After inspecting the theatre space at Webster Groves High School, ITC is declining to submit a bid to update the rigging and the softgoods. In order to perform work OSHA safety concerns would need to be addressed. Additionally during my inspection I discovered other safety concerns that should be addressed for the safety of the space. Please see below for photos and notes. This list is not a comprehensive list of issues a licensed mechanical contractor should be contracted to diagnose and address all issues in this space.

**From:** Todd Schaefer  
**Sent:** Thursday, March 15, 2018 1:37 PM  
**To:** Rob Steuber  
**Subject:** RE: Meeting

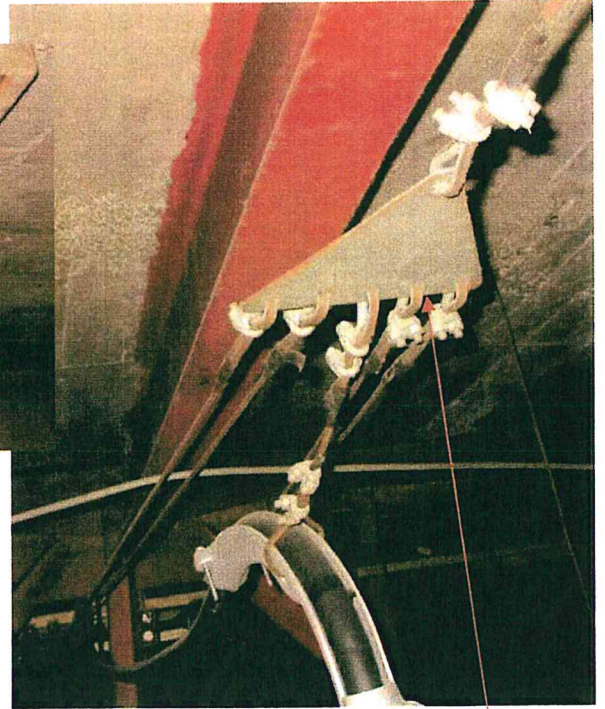
I was unable to inspect the head blocks or loft blocks for the fly system because the ladder to the grid was not code compliant. It lacks a safety cage and was inadequately affixed to the building structure.

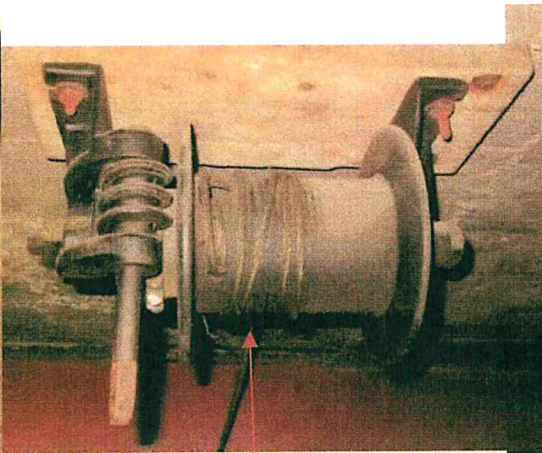
In the fly gallery there is insufficient space to work on the rigging.

Additionally handrail height does not meet OSHA requirements. There is no secure point for workers to tie off for fall protection.

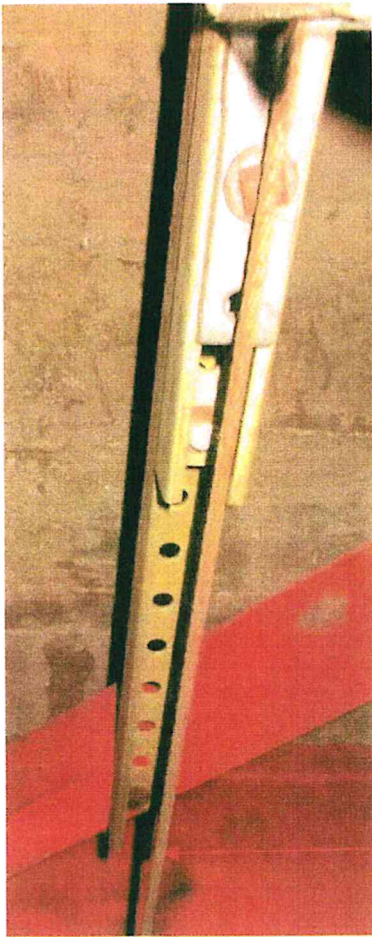
Non rated hardware affixing track to building structure

Inappropriately revved drum wire rope is crossing itself

Inadequate clew block non rated wire rope clips inappropriately applied wire rope clips inadequate turnback

Track sections for FOH electric stacked and inappropriately attached.

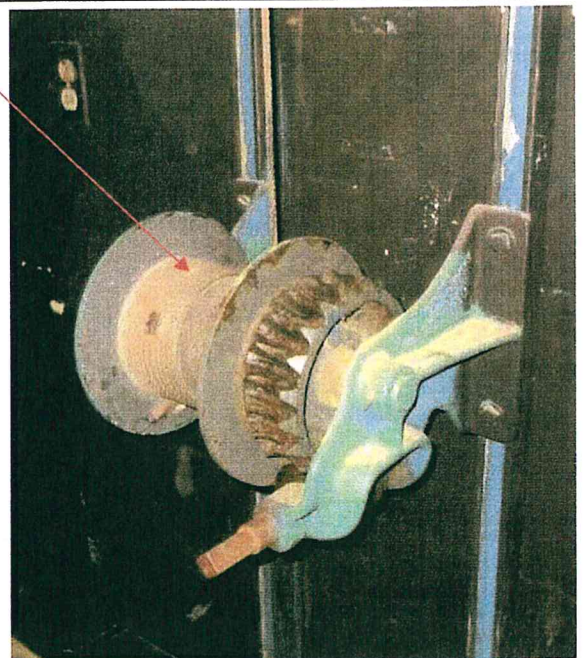
Drum for FOH lacks a mechanical stop, drum is attached to track, hardware for attachment is not rated

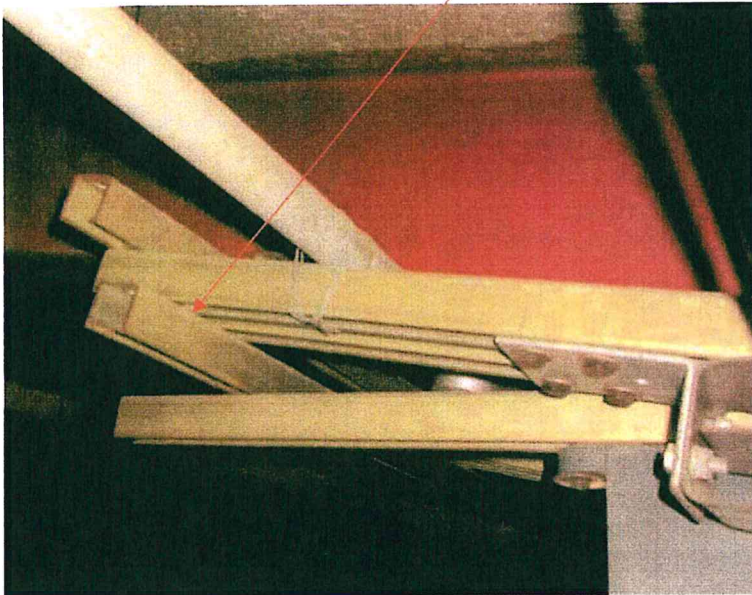
Access to lighting positions in attic does not have PPE points for harness and has no handrails

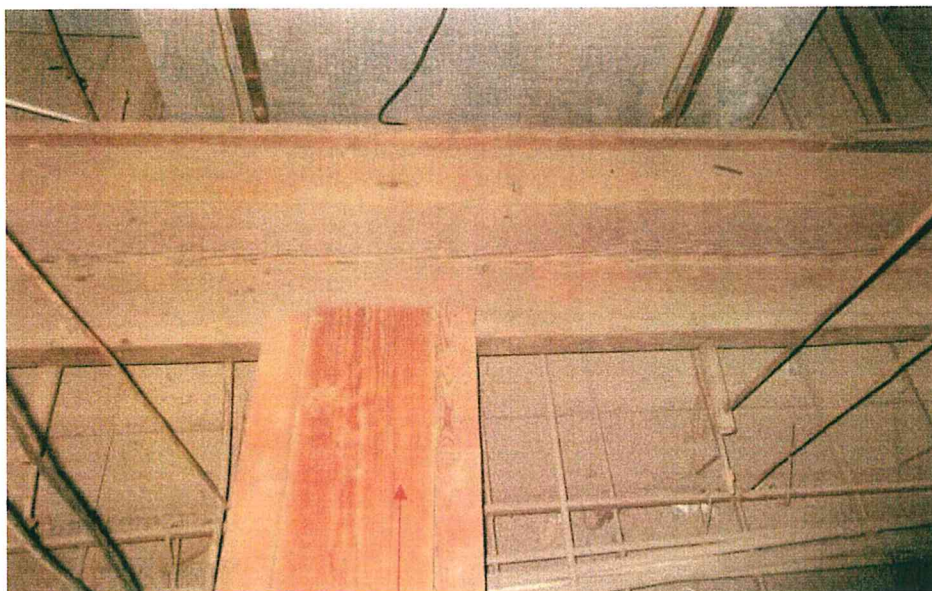
Access to attic area is too small and ladder is homemade and not stable.
